# Author Comments (ACs)

Tang, G., Nicholls, Z., Jones, C., Gasser, T., Norton, A., Ziehn, T., Romero-Prieto, A., and Meinshausen, M.: Investigating Carbon and Nitrogen Conservation in Reported CMIP6 Earth System Model Data, EGU sphere [preprint], <https://doi.org/10.5194/egusphere-2024-3522>, 2024.

# RC1: 'Comment on egusphere-2024-3522', Anonymous Referee #1, 20 Dec 2024

# RC2: 'Comment on egusphere-2024-3522', Anonymous Referee #2, 16 Jan 2025

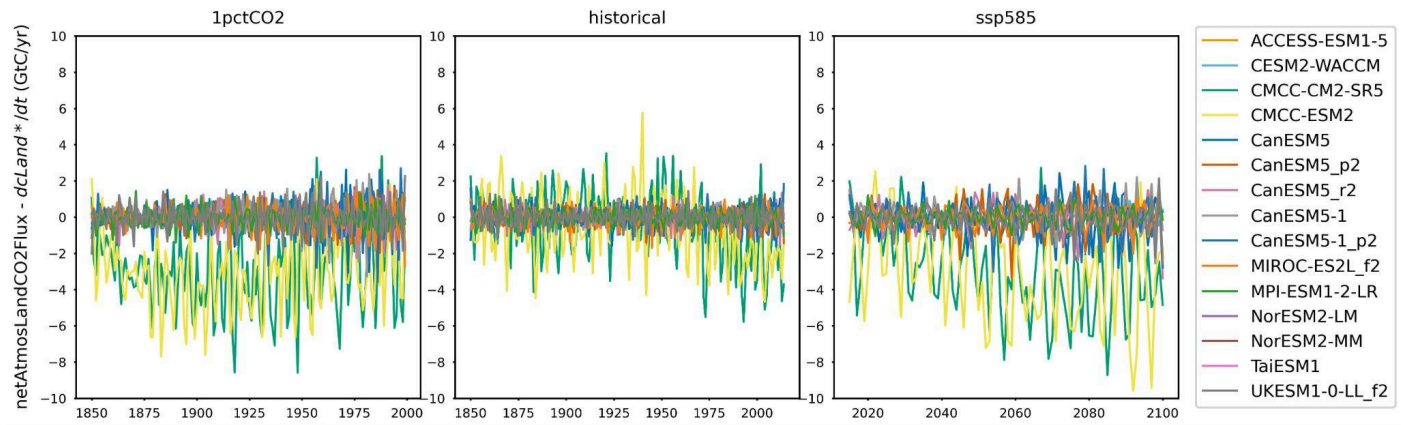
Fig. A4. Please extend the y-axis to fully display the negative values.

GT: Thanks we have updated the figure A4.
